Commercial Plans RECEIVED 3/17/2025 DEPARTMENT OF ENGINEERING ENGINEERING REVIEW COPY

**NEW OFFICE / STORAGE**

38229 MANZELLA DRIVE, SLIDELL, LOUISIANA

DRAWING NUMBER: **C100**

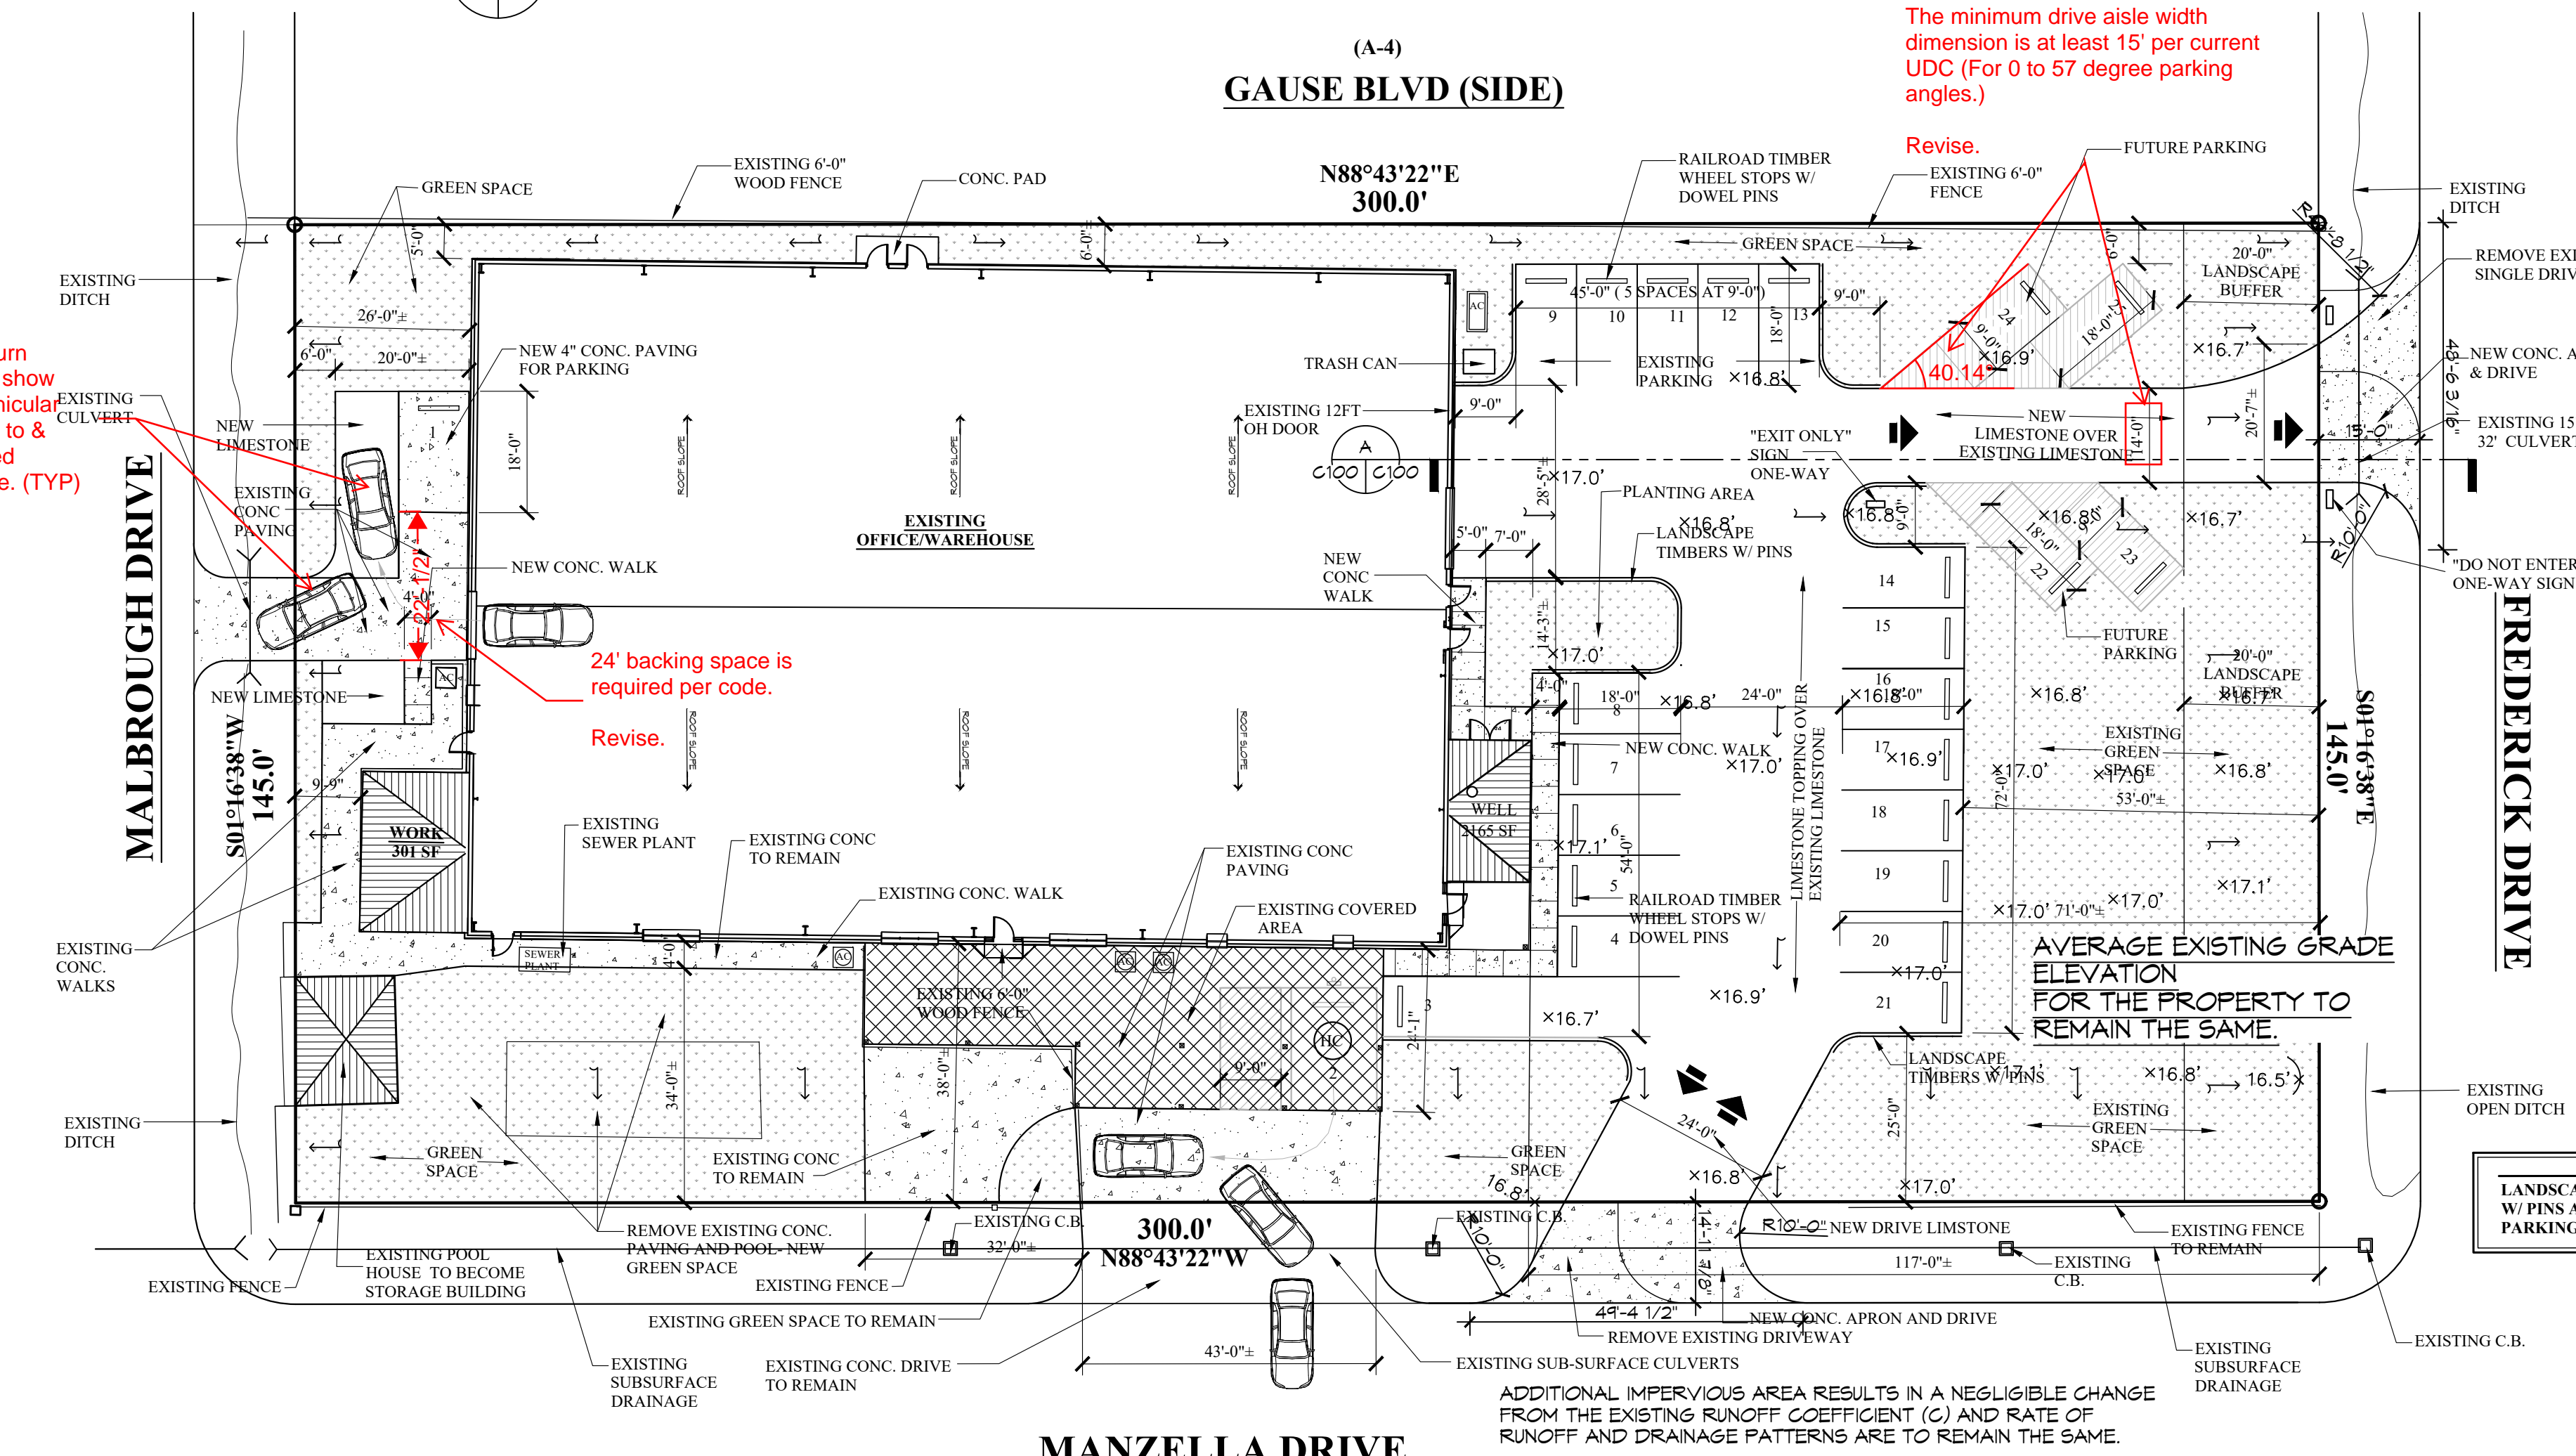
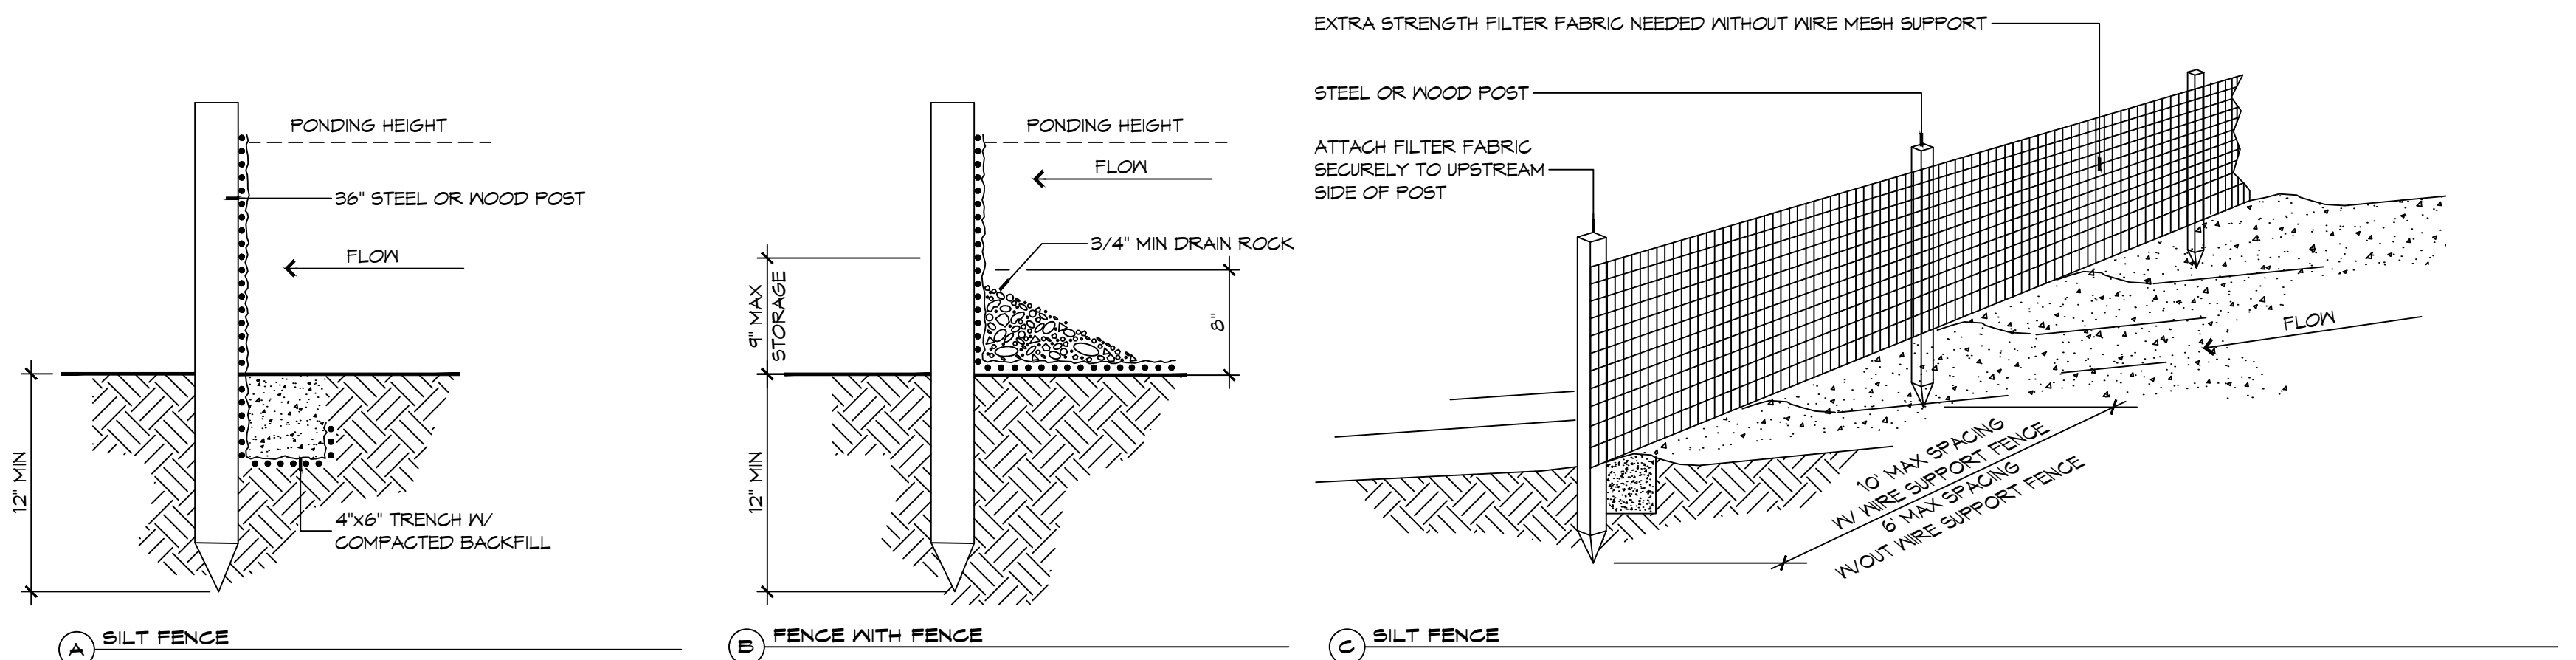
The minimum drive aisle width dimension is at least 15' per current UDC (For 0 to 57 degree parking angles.)

Revise.

Revise autoturn simulation to show proposed vehicular maneuvering to & from proposed parking space. (TYP)

24' backing space is required per code.

Revise.

Revise Runoff Coefficient (C) = 0.95 for watertight surfaces per STP Ordinance Sec. 900-6.3(F); Exhibit 900-6-6.

Revise Runoff Coefficient (C) = 0.7 for gravel per STP Ordinance Sec. 900-6.3(F); Exhibit 900-6-6.

Revise Runoff Coefficient (C) = 0.3 for greenspace per STP Ordinance Sec. 900-6.3(F); Exhibit 900-6-6.

(TYPICAL for both pre & post development.)

Provide "Weighted" Runoff Coefficient (C) for both pre & post development.

DRAWING NUMBER:  
**C101**

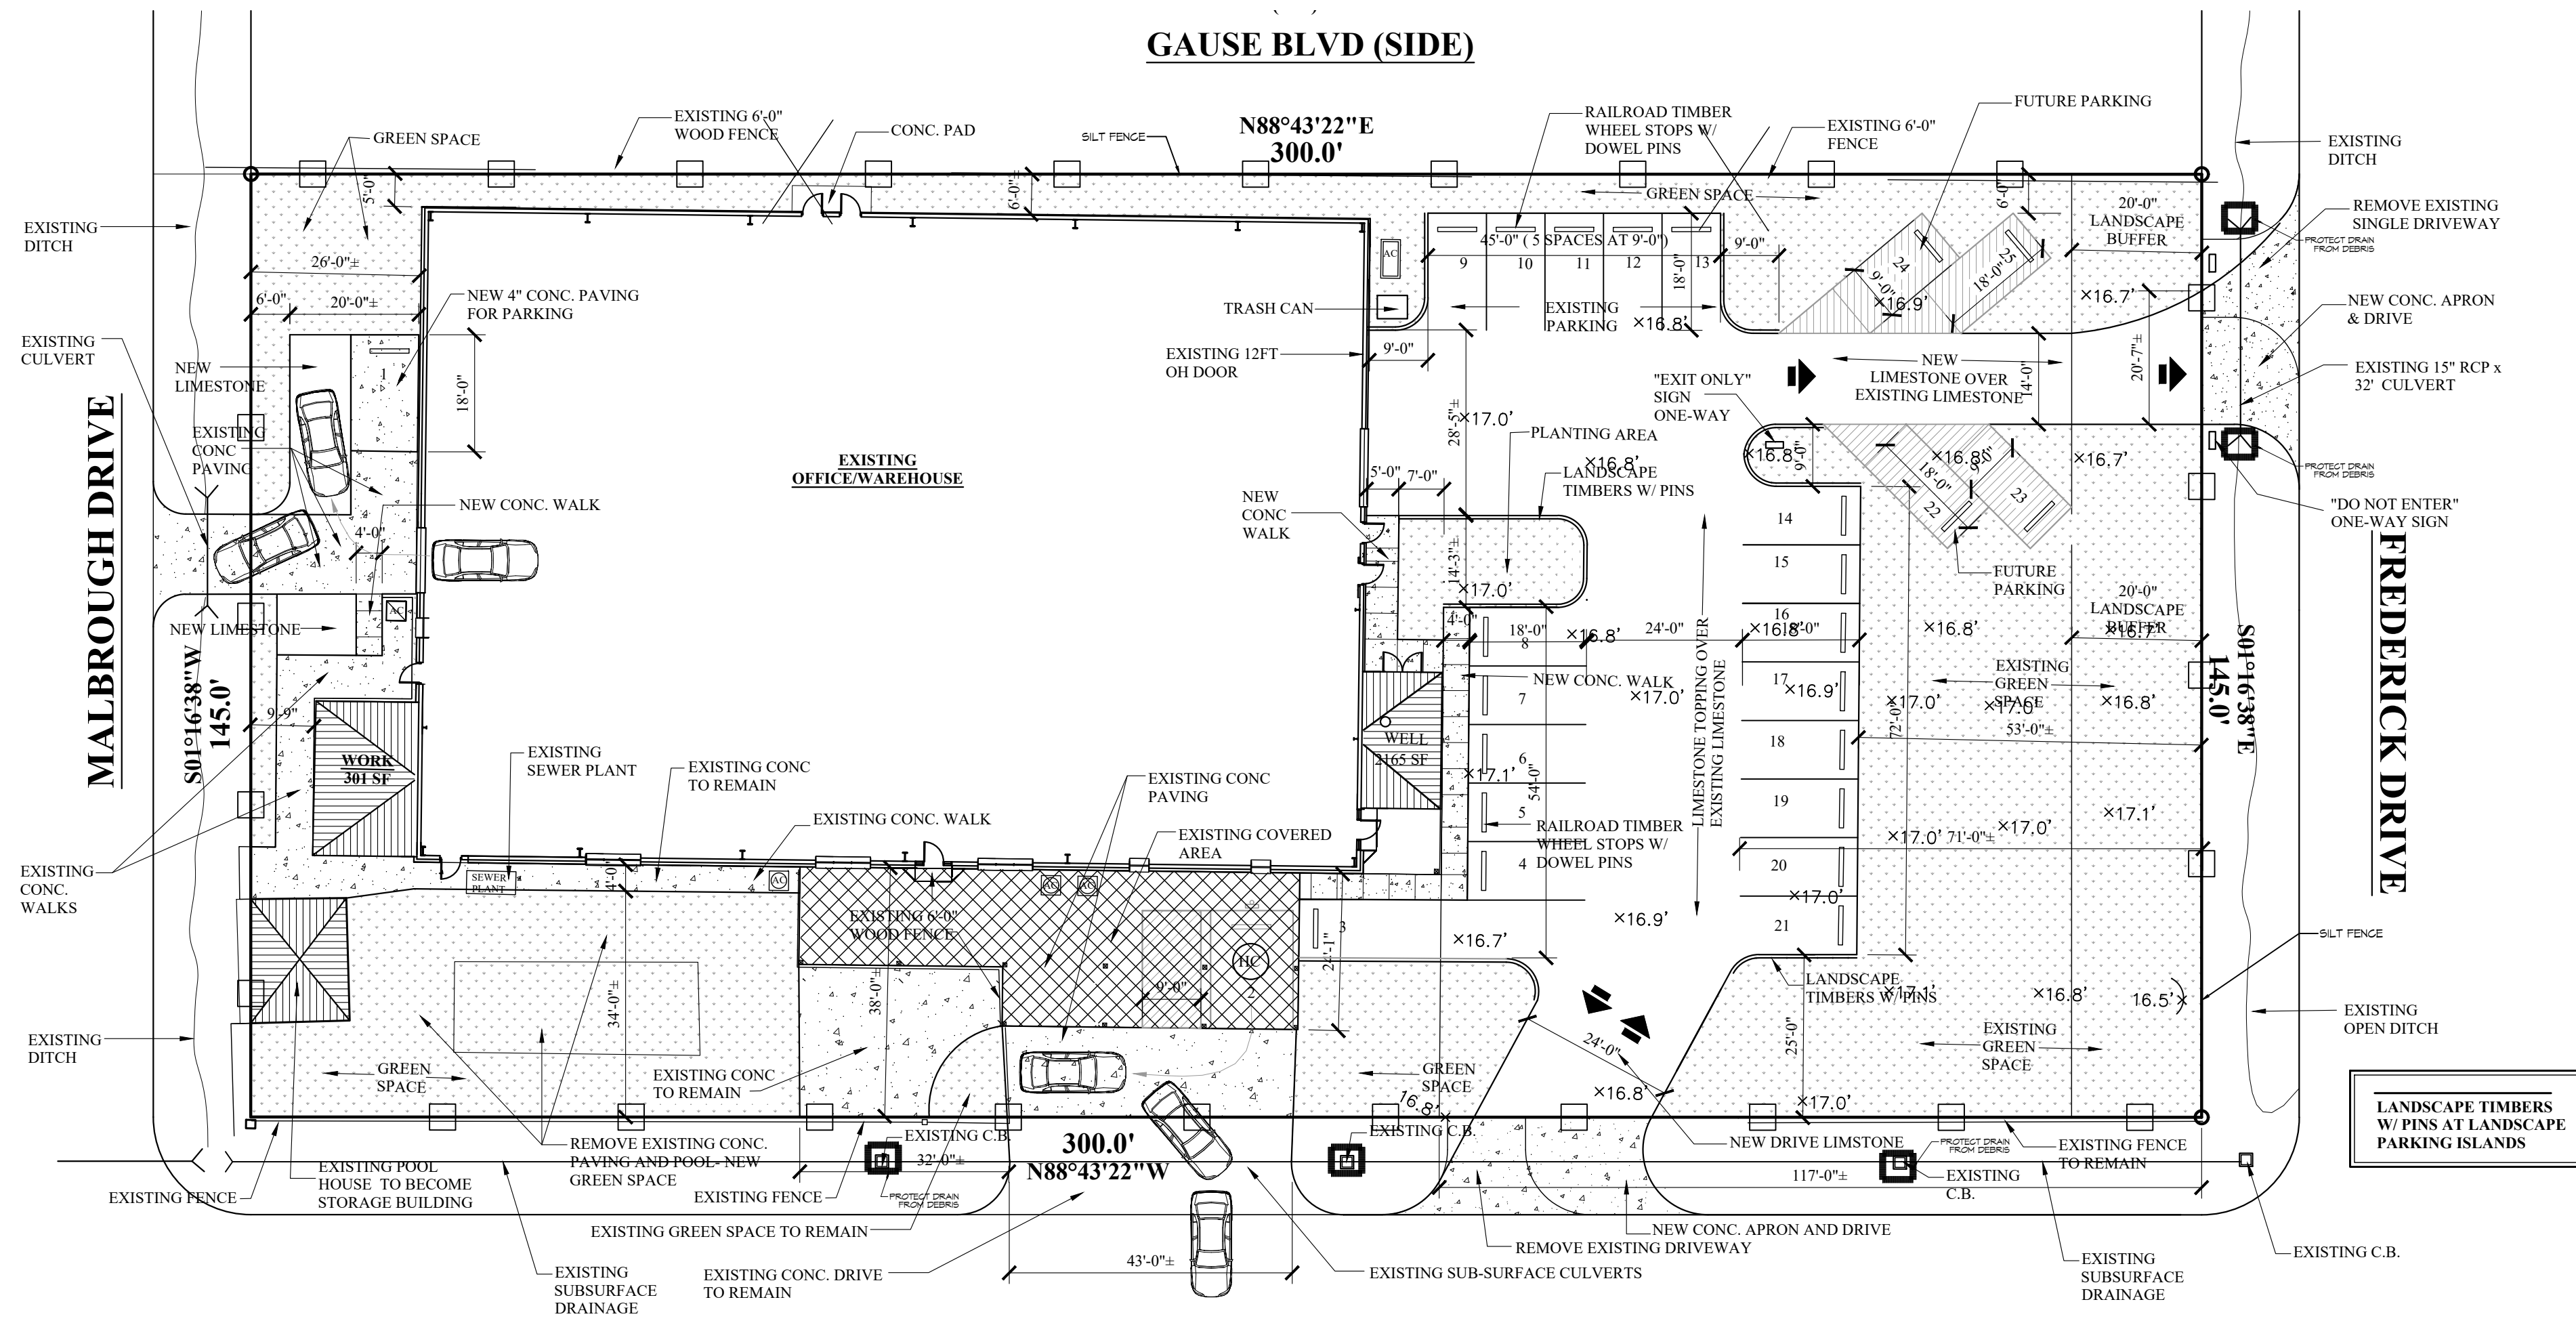
Provide STP Stormwater Agreement filled out and signed by the owner or contractor.
